**JOINT REGIONAL PLANNING PANEL  
(East)**

<b>JRPP No</b>	2014SYE118
<b>DA Number</b>	DA2014/1050
<b>Local Government Area</b>	Hurstville City Council
<b>Proposed Development</b>	Demolition of existing structures and construction of a mixed use development containing basement level car parking, ground floor commercial/retail area and twelve levels containing 93 residential units
<b>Street Address</b>	378, 380, and 384 Forest Road Hurstville
<b>Applicant/Owner</b>	Applicant: Icon Construction Group  Owner: Sydney South Gateway P/L
<b>Number of Submissions</b>	119 adjoining and adjacent owners/residents notified  Application advertised for fourteen (14) days  Two submissions and one enquiry received
<b>Regional Development Criteria (Schedule 4A of the Act)</b>	Value over \$20M
<b>List of All Relevant s79C(1)(a) Matters</b>	<ul style="list-style-type: none"> <li>▪ State Environmental Planning Policy No 55 - Remediation of Land</li> <li>▪ State Environmental Planning Policy No 65 – Design Quality of Residential Flat Development</li> <li>▪ State Environmental Planning Policy (Building Sustainability Index: BASIX) 2004</li> <li>▪ State Environment Environmental Planning Policy (Infrastr

Diagram showing three design options

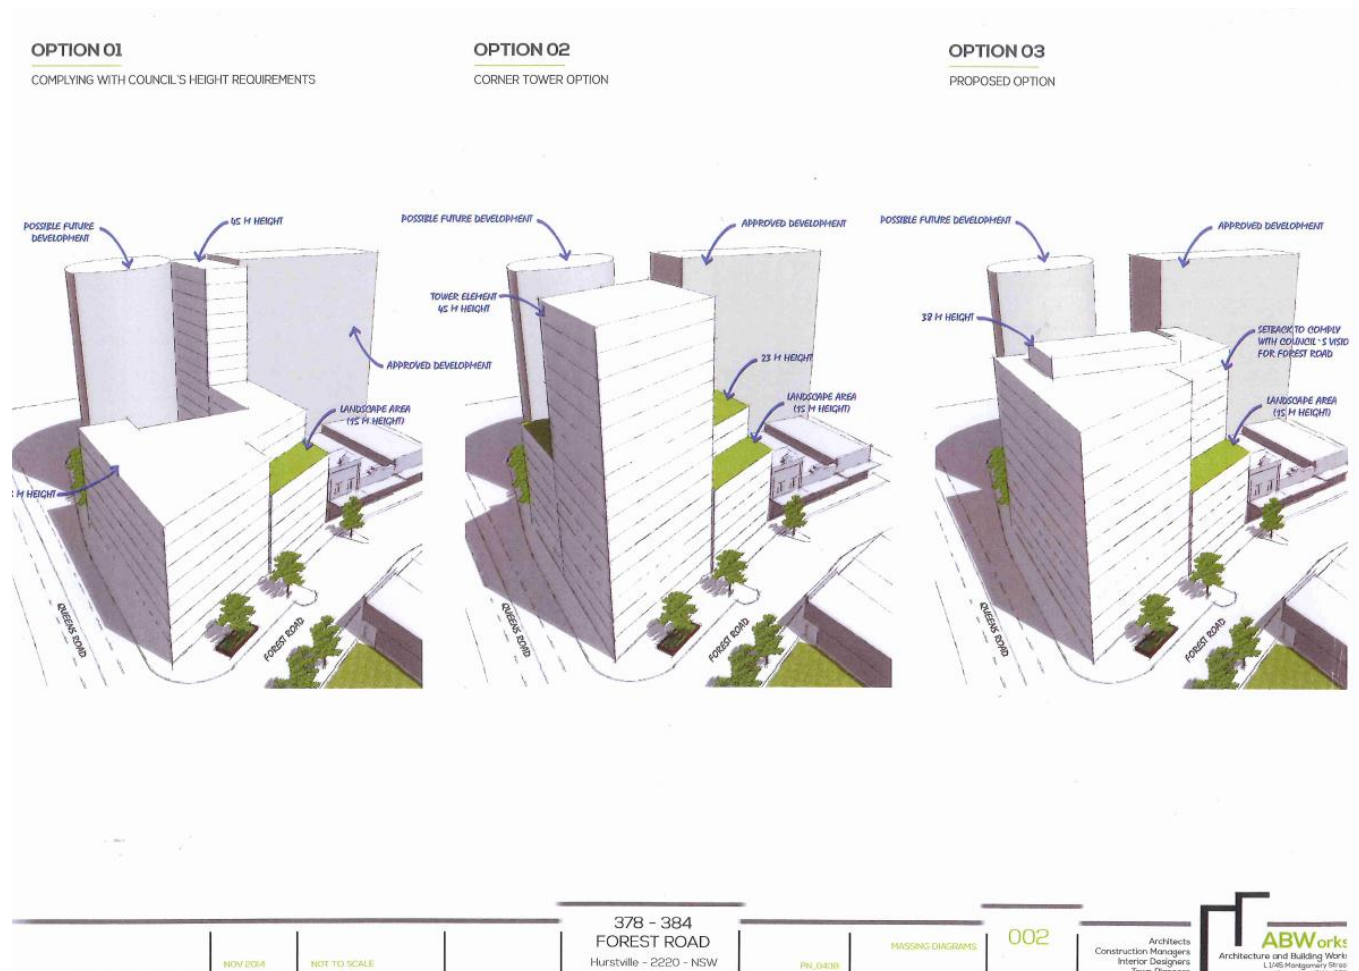
Following consideration the DRP advised the applicant that the preferred option was Option 2 which proposed shifting height with a taller building at the corner of Forest Rd and Queens Rd, rather than the rear as proposed in DCP 2, and stepping down the remaining building where the site adjoins properties on Forest Rd and Queens Rd. The diagram presented to the DRP by the applicant is shown below.

The revised design submitted after the DRP increases the height from 11 to 13 storeys on the corner and the decreased height from 11 to 9 storeys north east and south east. The form is an improvement to the bulk along the street frontages and transitions better to the planned lower height along Forest Road.

Following the DRP meeting, the applicant revised the detailed design align with massing Option 2.

The Urban Design Report prepared by ae design partnership dated 17 December 2014 which accompanies this application provides a detailed discussion on context. The amended plans reflect the massing of Option 2 previously presented to the DRP.
